# Technical Service Bulletin

<b>Topic</b>	HVAC failing to cool   DTC B16A1F0 in diagnostic address 00C5   Bentayga Series (Hybrid)   23MY - 25MY
<b>Market area</b>	Australia E04 Bentley rest Asia and Australia (6E04),China 723 Volkswagen (Anhui) Automotive CO (6723),China 796 VW Import Comp. Ltd (Vico), Beijing (6796),Germany E02 Bentley rest Europe (6E02),Japan E03 Bentley Japan (6E03),Korea, (South) E08 Bentley South Korea (6E08),United Arab Emirates E06 Bentley Middle East and Africa (6E06),United Kingdom E01 Bentley UK (6E01),United States E05 Bentley USA and rest America (6E05)
<b>Brand</b>	Bentley
<b>Transaction No.</b>	2071190/3
<b>Level</b>	EH
<b>Status</b>	Released for publishing
<b>Release date</b>	Dec 10, 2025

Figure 1

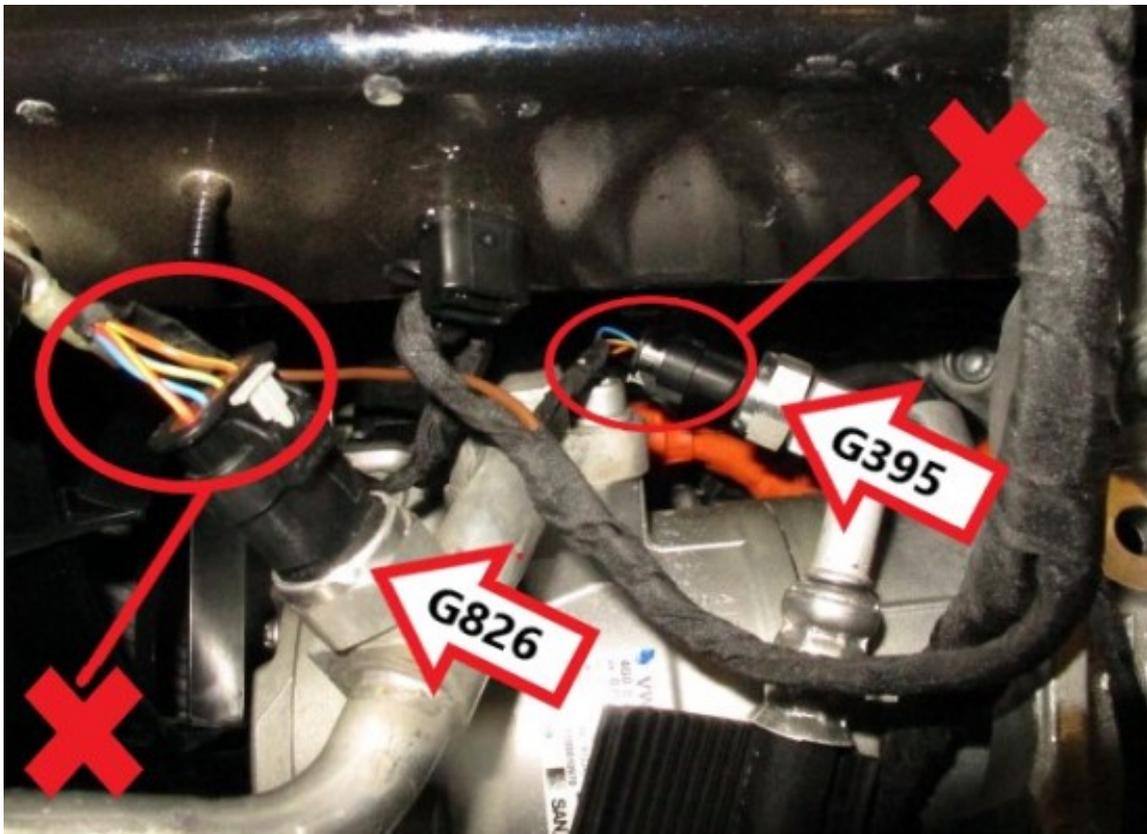
- 1) Referring to Rep.Gr 44 - Remove the left hand front wheel
- 2) Referring to Rep.Gr 66 - Remove the left hand front foremost wheel arch liner
- 3) Remove (x3) speaker box fixings (5Nm)
  - Disconnect the speaker box electrical connector
  - Remove the speaker box
- 4) Access can now be gained to the required connector plugs - Figure 1 shows G826 and G395 with the connector plugs fitted incorrectly
  - Low pressure sender G826 connector plug with 4 wires **(Incorrect)**
  - High pressure sender G395 connector plug with 3 wires **(Incorrect)**

In the event the pressure sender connector plugs are fitted incorrectly the plugs should be disconnected and refitted correctly as shown in Figures 2 and 3

Figure 2

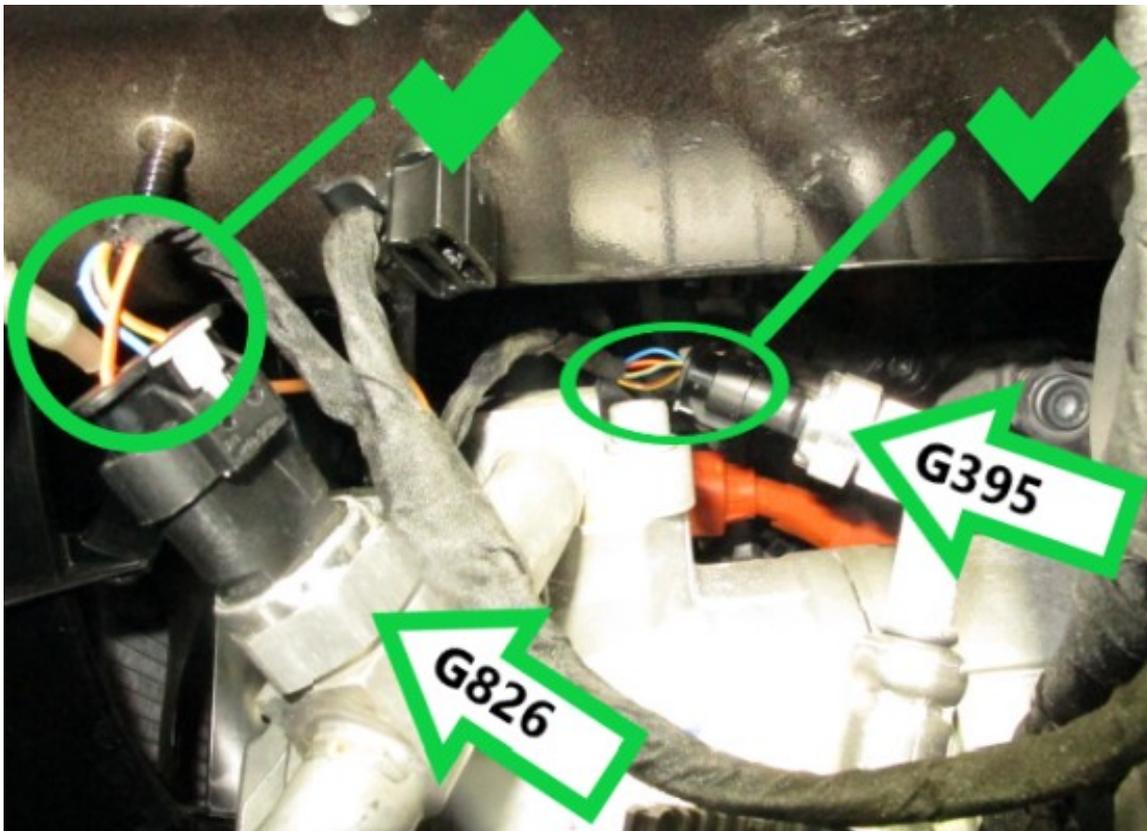
- Figure 2 shows G826 and G395 connector plugs fitted correctly
- Low pressure sender G826 connector plug with 3 wires (**Correct**)
- High pressure sender G395 connector plug with 4 wires (**Correct**)

Figure 3

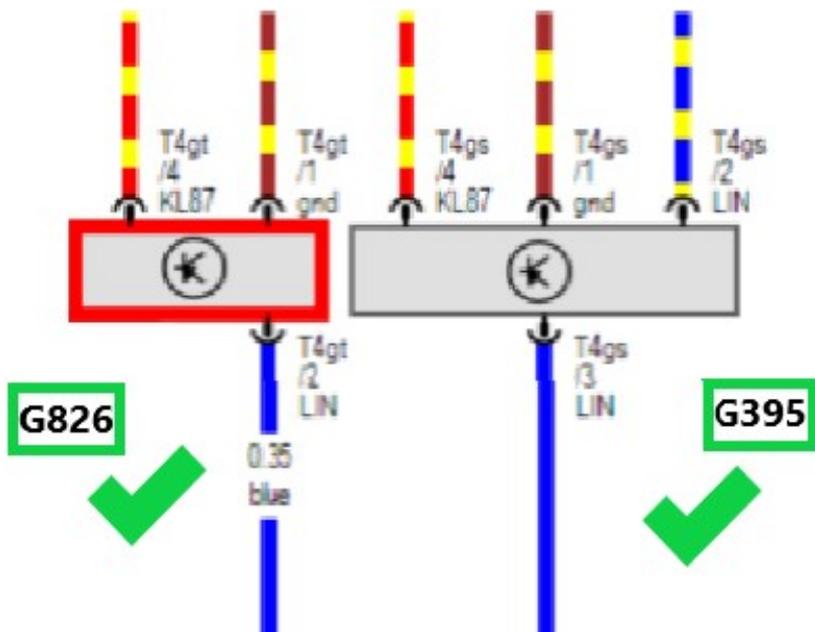
Hint: Figure 3 shows G826 and G395 as per the applicable Current Flow Diagram (Correct)
